ADDENDUM NO. 02

September 18, 2020

Project: Buckley Readiness Center POV Lot Improvements Washington Military Department, State Project #2020-627

Sheet No.
C1.00
2 of 5 Sheets

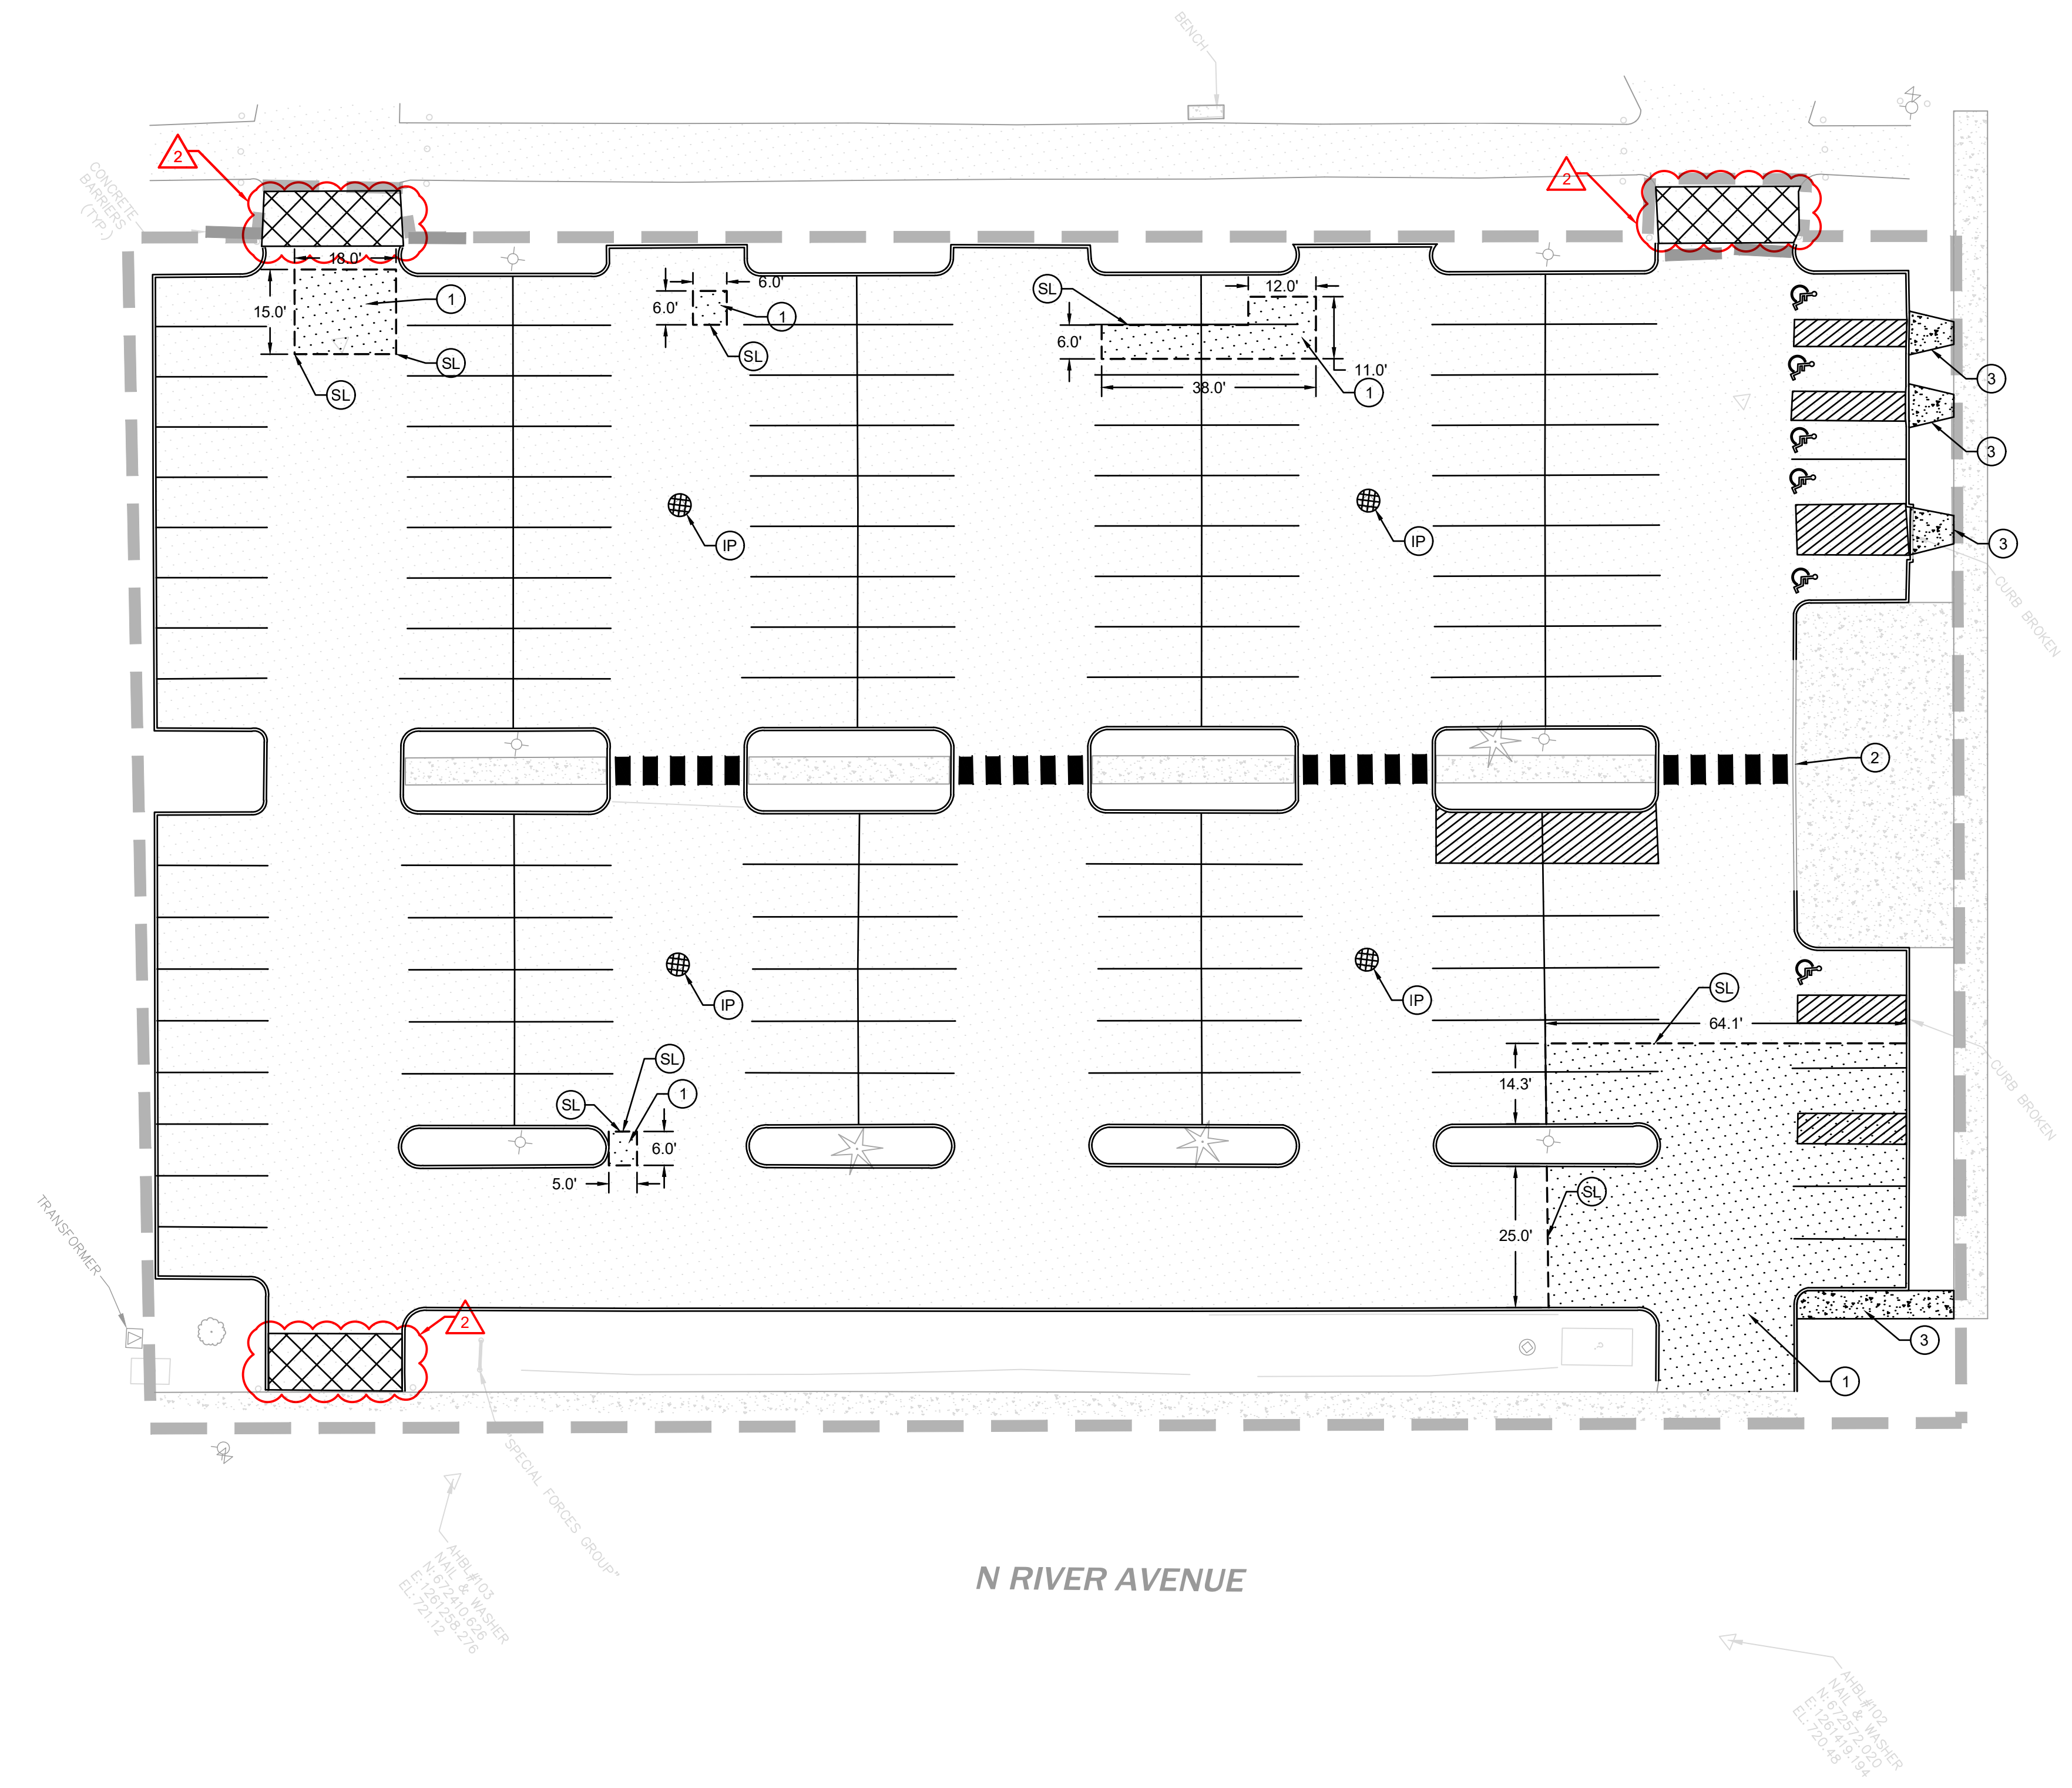
Item #02-02 Replace Sheet C1.00
ADD #02 Depict areas of 2" asphalt grind and overlay.

Clarify curb removal is extruded curb.

Remove Keynote #4 (existing ADA striping to be overlaid with HMA).

C2.00
3 of 5 Sheets

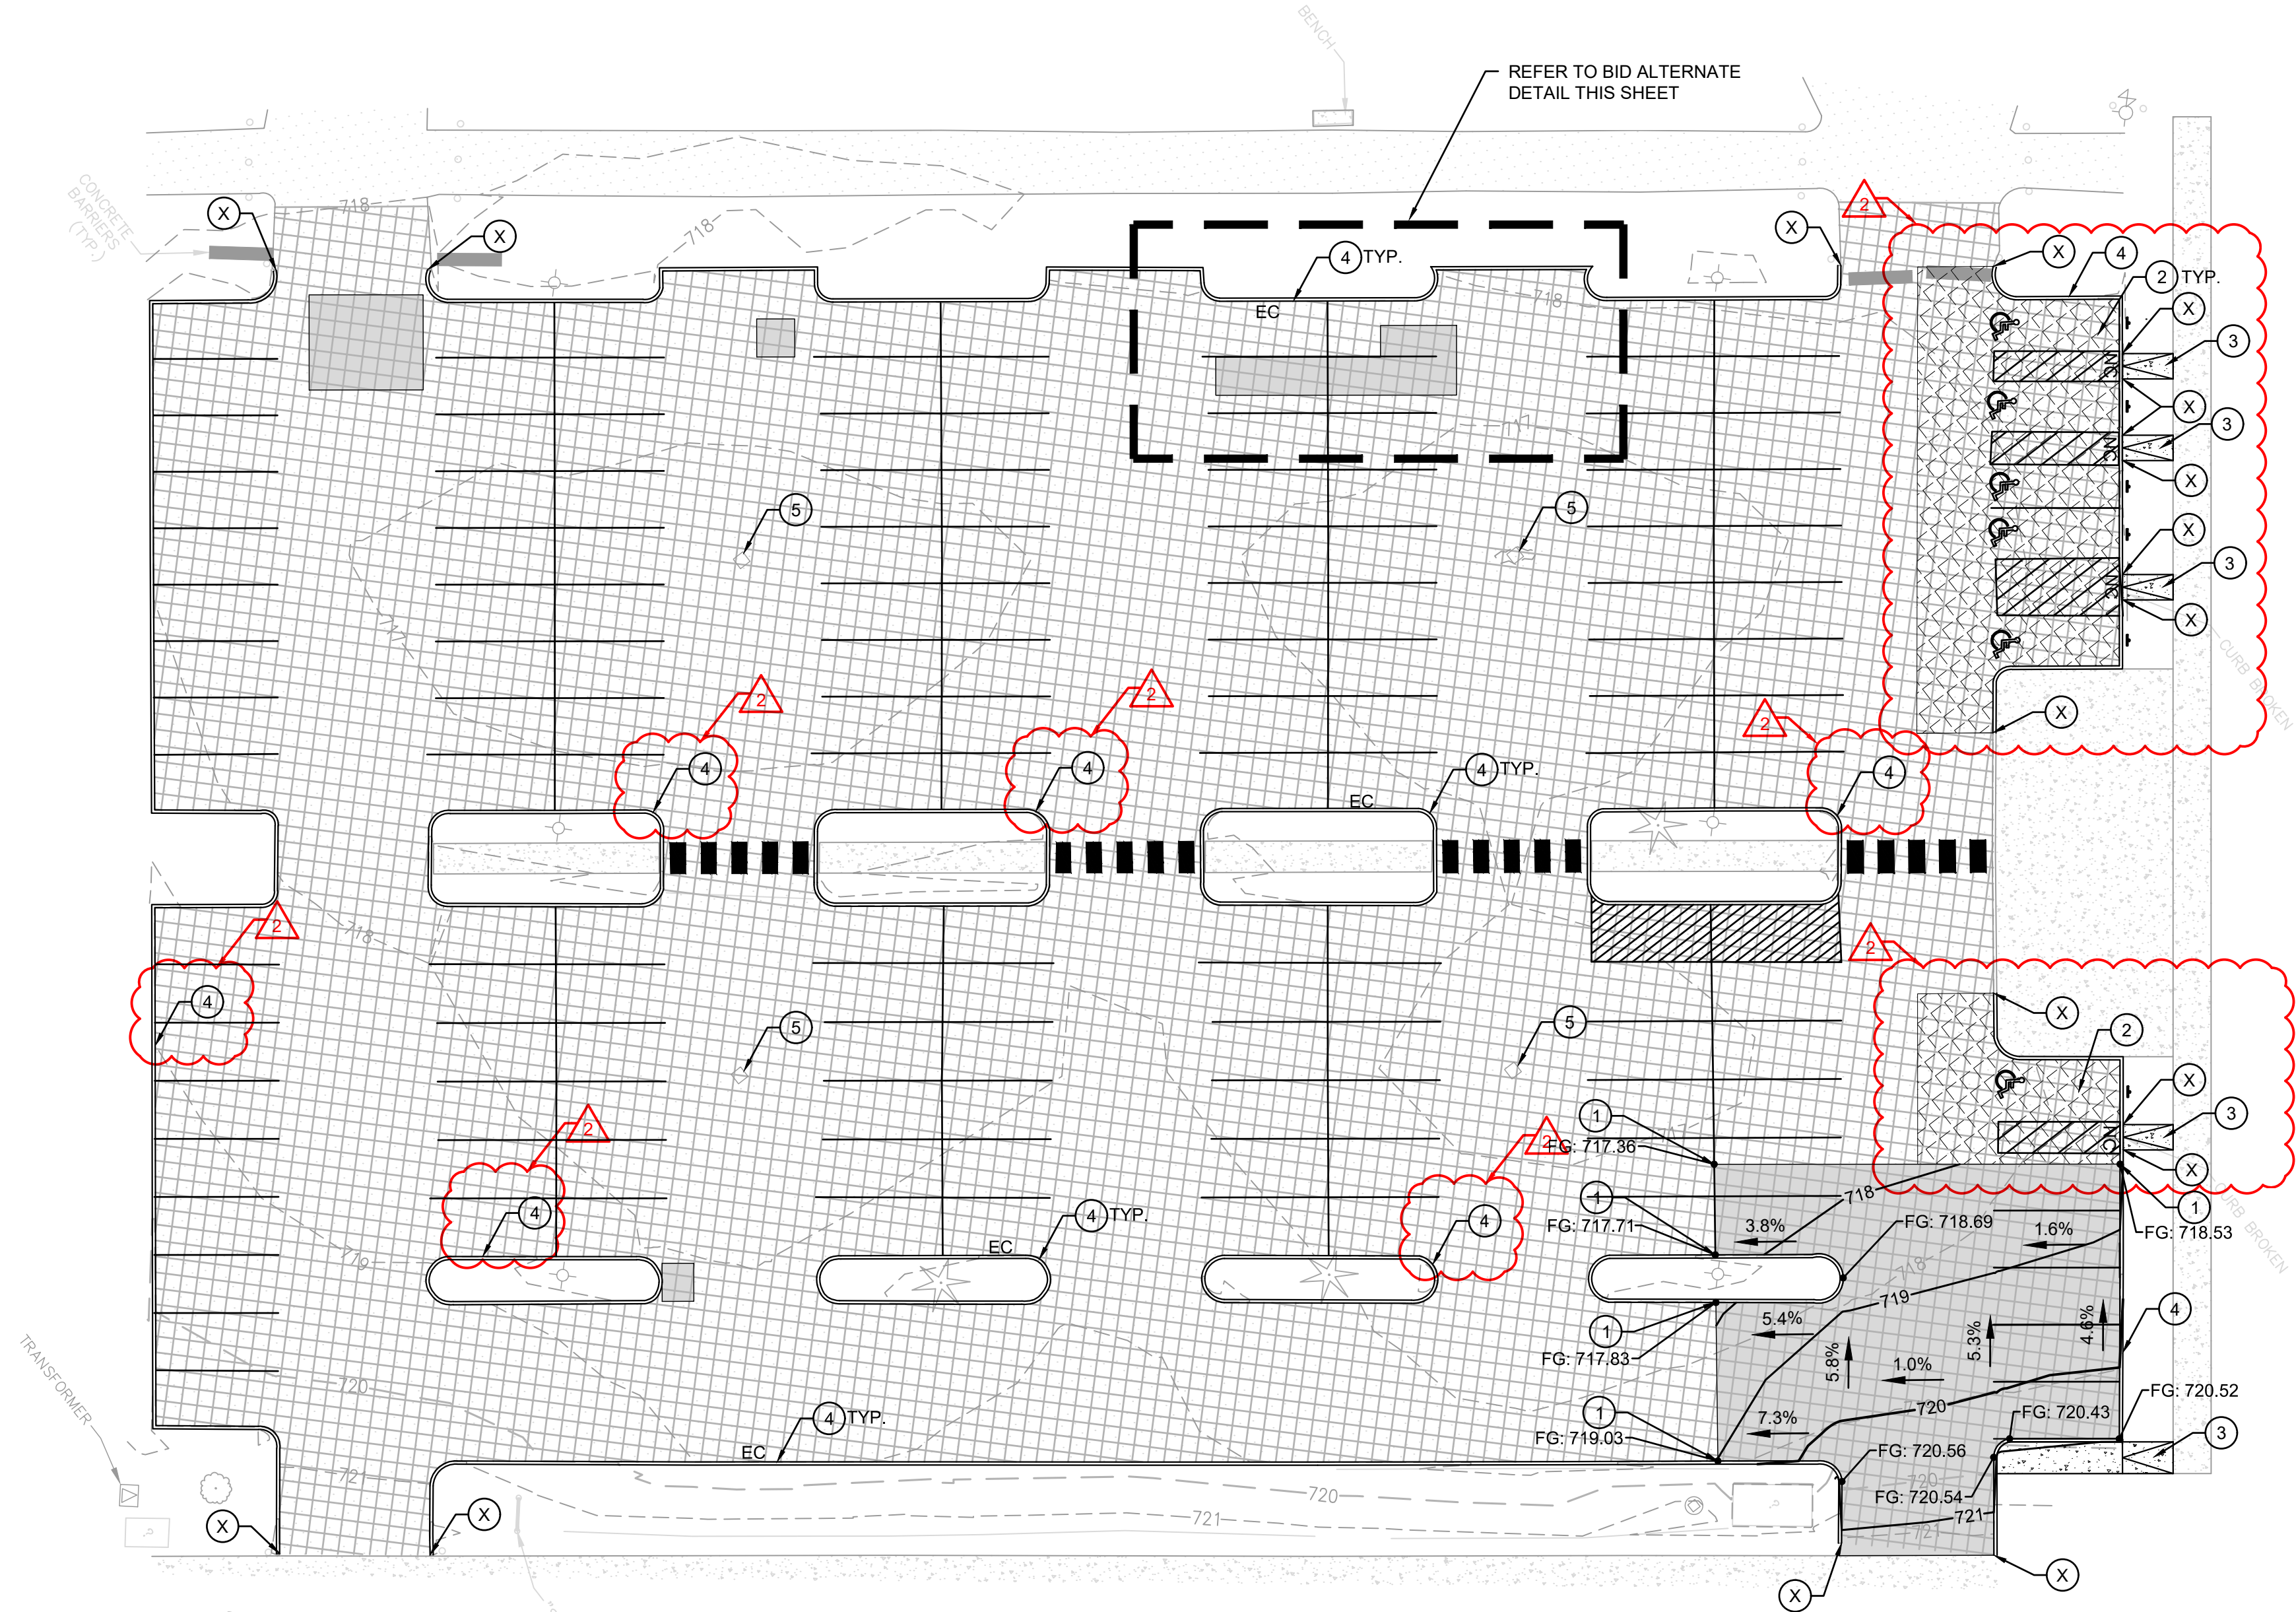
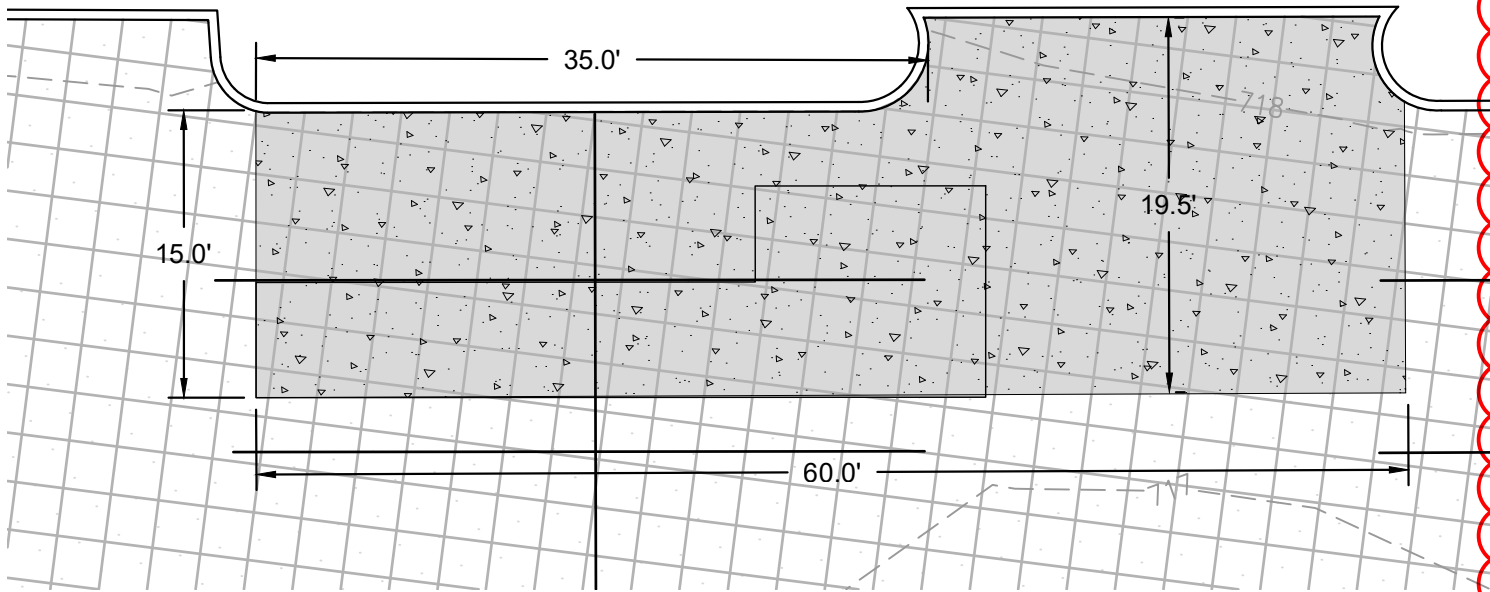
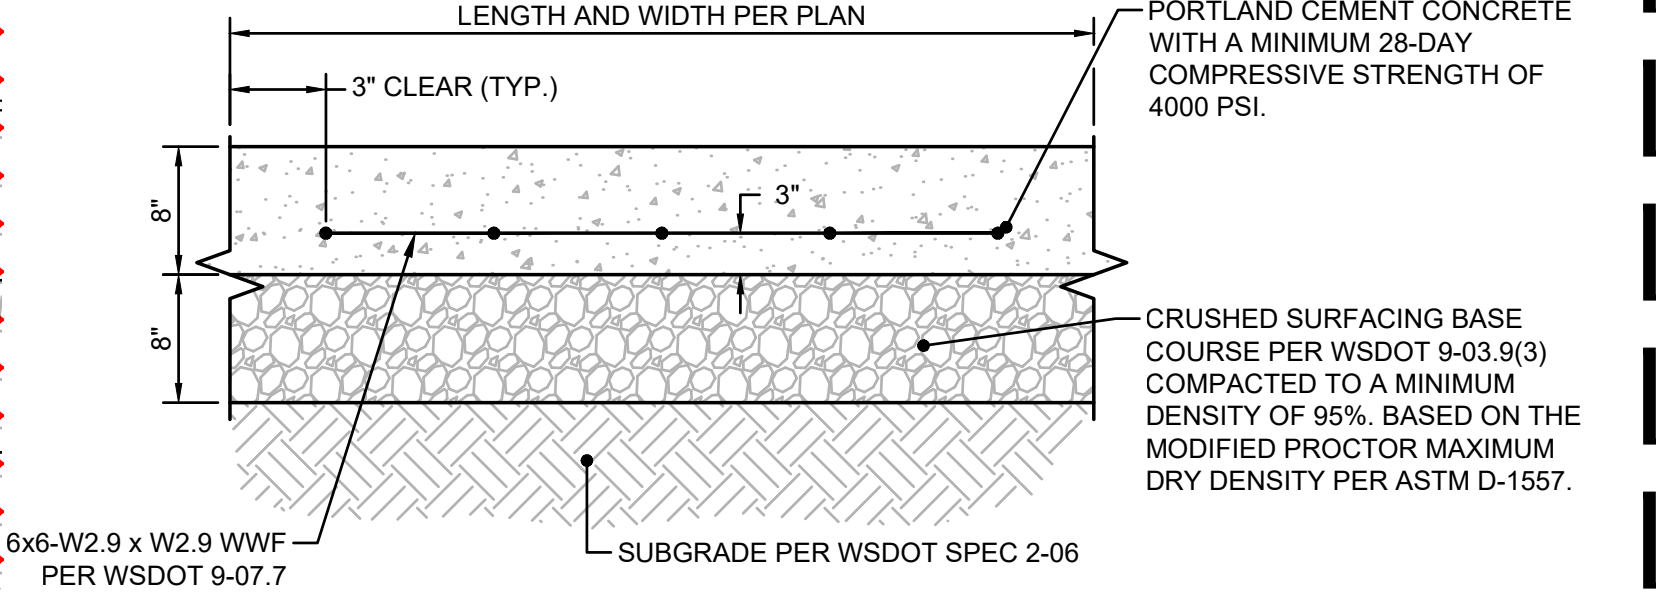
Item #02-03 Replace Sheet C2.00
ADD #02 Depict and call out (Keynote #2) HMA pre-leveling in ADA parking areas.

Specify extruded curb height reduction at concrete walkways and taper length (Keynote #4). Add Keynote #4 callouts to plan to indicate that all existing extruded curb is being replaced with new extruded curb.

Revise General Note #4 to allow alternate methods of cleaning existing pavement per paving fabric manufacturer's guidelines.

Revise location of WWF in Bid Alternate 1 concrete section.
